HOPE CREEK GENERATING STATION  
DOCKET NO. 50-354  
DRAFT SAFETY EVALUATION REPORT  
OPEN ITEM STATUS

DSER Open Item No. 5 a, b and d (DSER Section 2.4.5)

## WAVE IMPACT AND RUNUP ON SERVICE WATER INTAKE STRUCTURE

SERVICE WATER INTAKE  
STRUCTURE - FLOOD  
PROTECTION

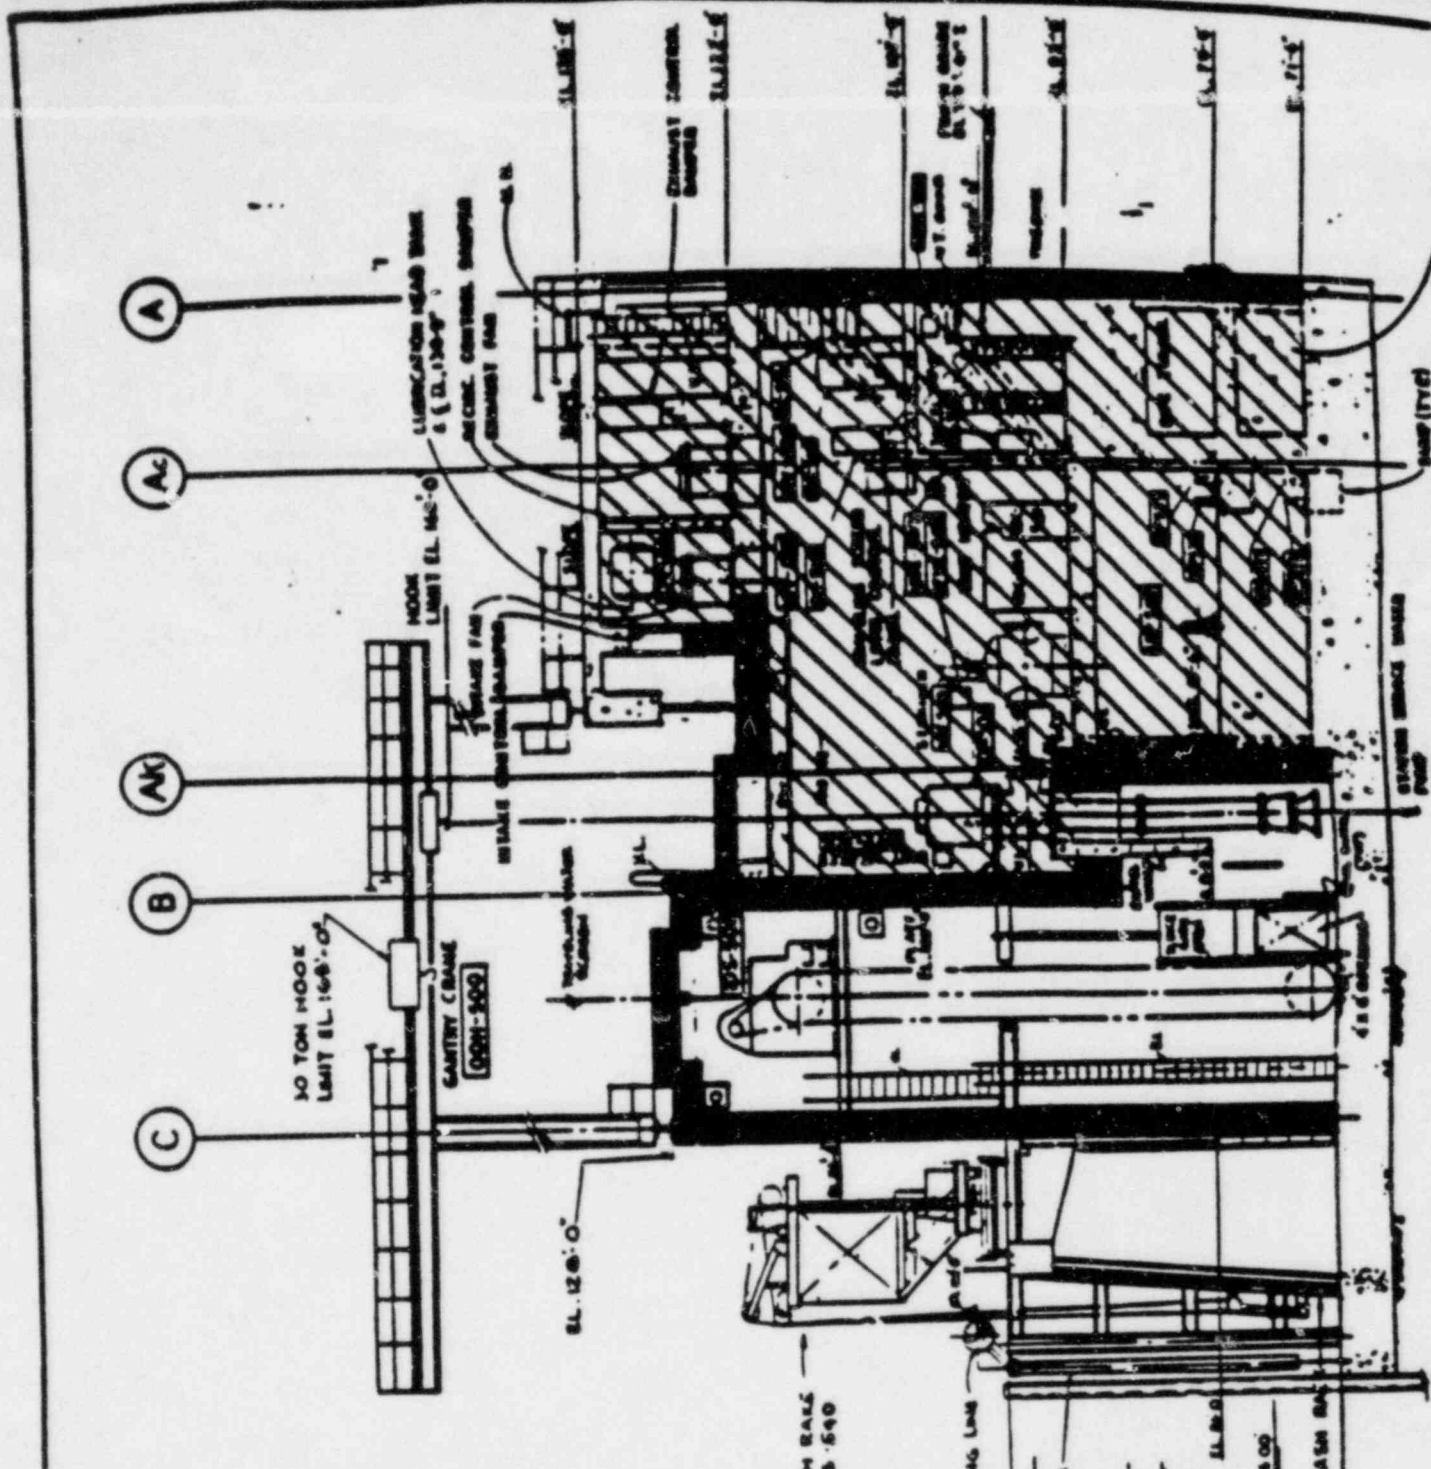
Provide a figure(s) in the FSAR which shows the protection of the station service water system from the flood water (including wave effects) of the design basis flood.

The general arrangement of the intake structure is provided in Figures 1.2-40 and 1.2-41. Section AA of Figure 1.2-41 is reproduced here as Figure 410.69-1 which identifies the watertight areas and the walls and slabs designed to accommodate flood loads. As described in Sections 2.4.2 and 2.4.5, the south and west exterior walls of the intake structure are subject to a maximum wave run-up elevation of 134.4 feet due to the probable maximum hurricane (PMH). Such waves could overtop the roof of the western portion of the structure at elevation 128 feet. However, a rigorous analysis has been performed to determine the depth of water in the low area (elevation 122.0 feet) after wave impact and to confirm that water does not enter the building through the air intake control dampers (bottom elevation 128.5 feet). Therefore, flood water will not enter into the dry area of the intake structure. On the north side of the intake structure, the maximum water level will be only slightly higher than the still water elevation (113.8 feet) during the PMH. According to Table 2.4.6, the maximum wave elevation for the north side of the intake structure is 26.3 feet MSL (elevation 115.3 feet) due to a postulated multiple dam break. Therefore, flood protection of the north exterior wall to elevation 121.0 feet is adequate.

Fig. 2 Fetches for Service Water Intake Structure, Hope Creek Generating Station.

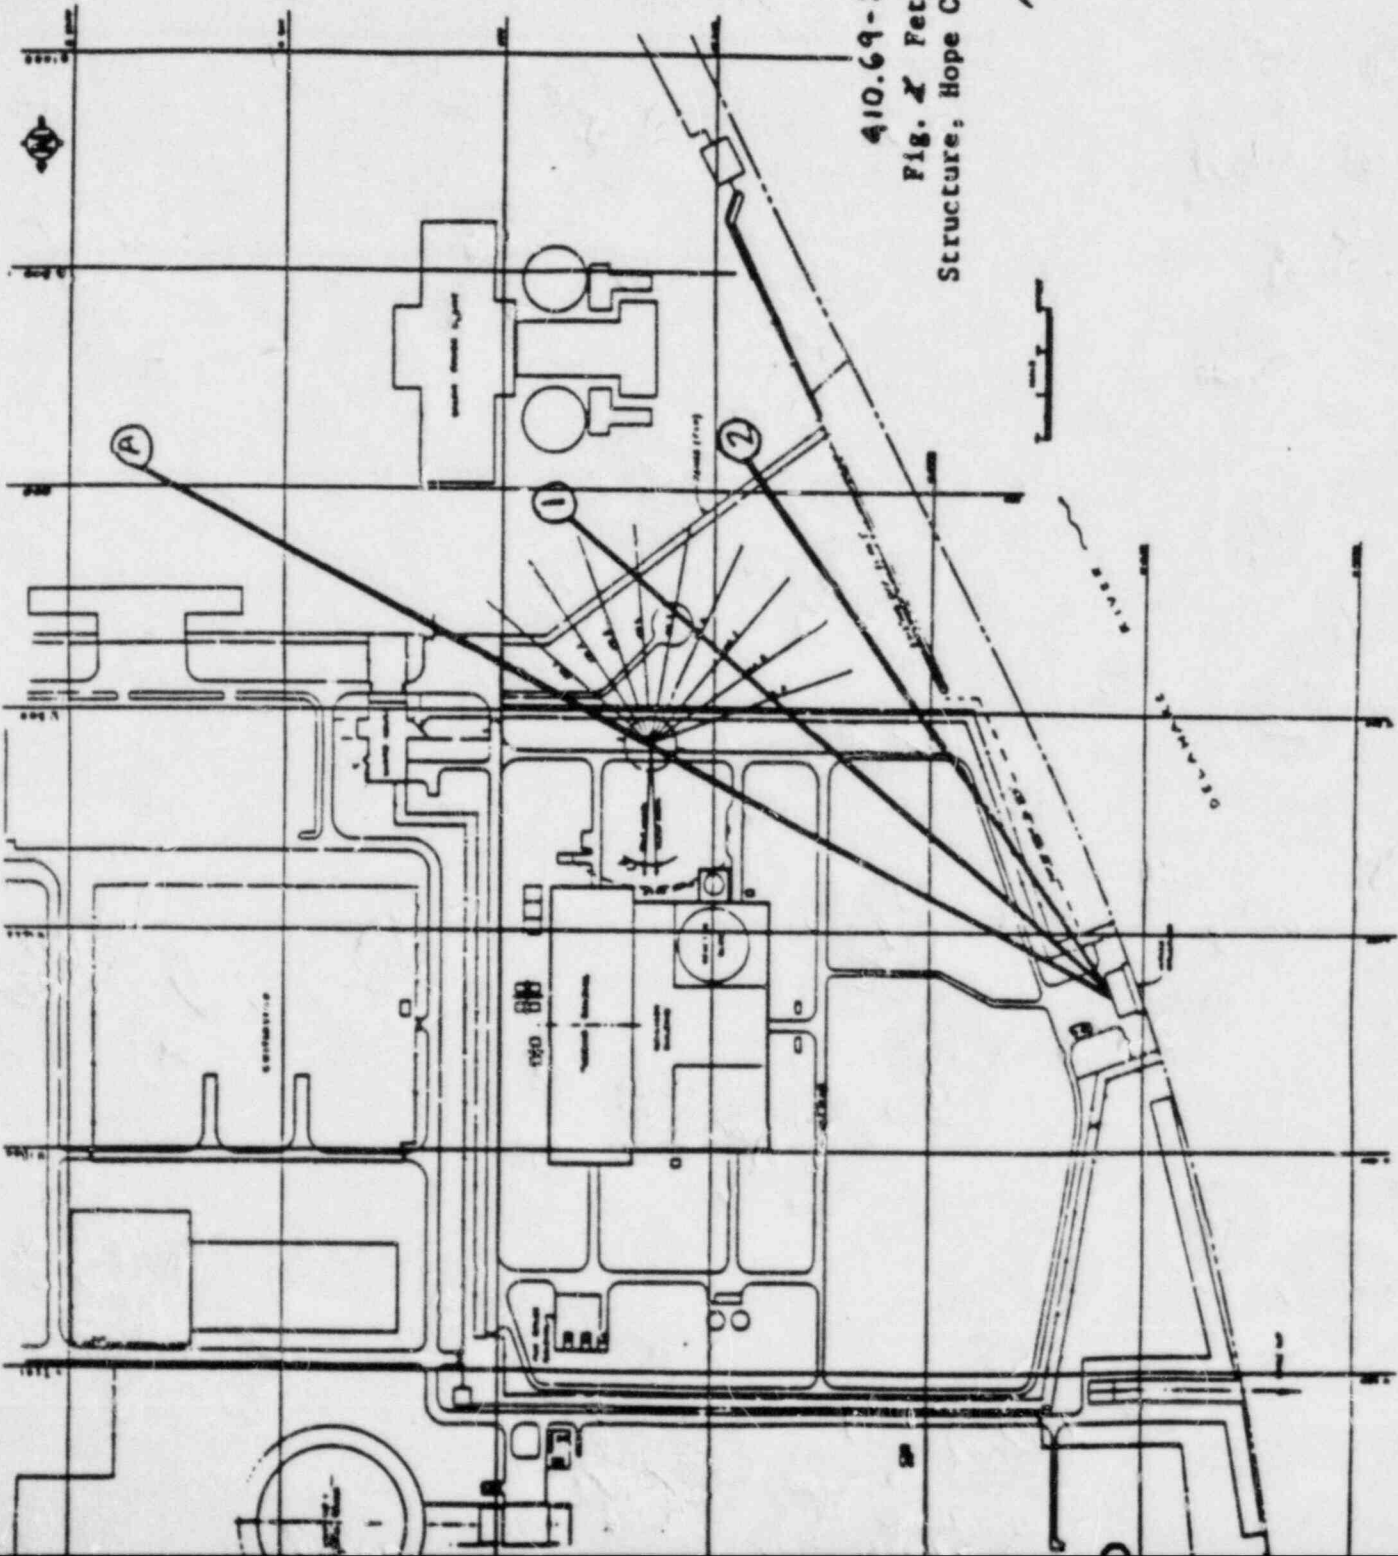
The staff has requested the applicant to provide additional information on the waves that impact on the river face of service water intake structure. The waves impacting on this face of the structure are not reduced in height (depth-limited) as those that traverse plant grade.

On the east side of the intake structure, the maximum wave run-up elevation due to the PMH equals 121.97 feet. This elevation is due to a 18 wave traveling in the direction of Fetch "A". Fetch A, which is rotated about 15 degrees from Fetch 1 (as shown in Figures 410.69-2 and 410.69-3), is chosen to maximize the wave run-up elevation. Since this elevation is lower than the bottom of the HVAC exhaust opening, flood water will not enter the intake structure from the east side of the building.

The attached Figure 1 shows the fetches considered for wave runup on the service water intake structure (SWIS). Fetch A, which has an azimuth of  $119^\circ$ , is 4800 feet long over the island and passes between the Salem Plant and the Hope Creek Generating Station. The wave front from Fetch A approaches the east wall of the service water intake structure at an oblique angle equal to  $55^\circ$  (see Figure 1).
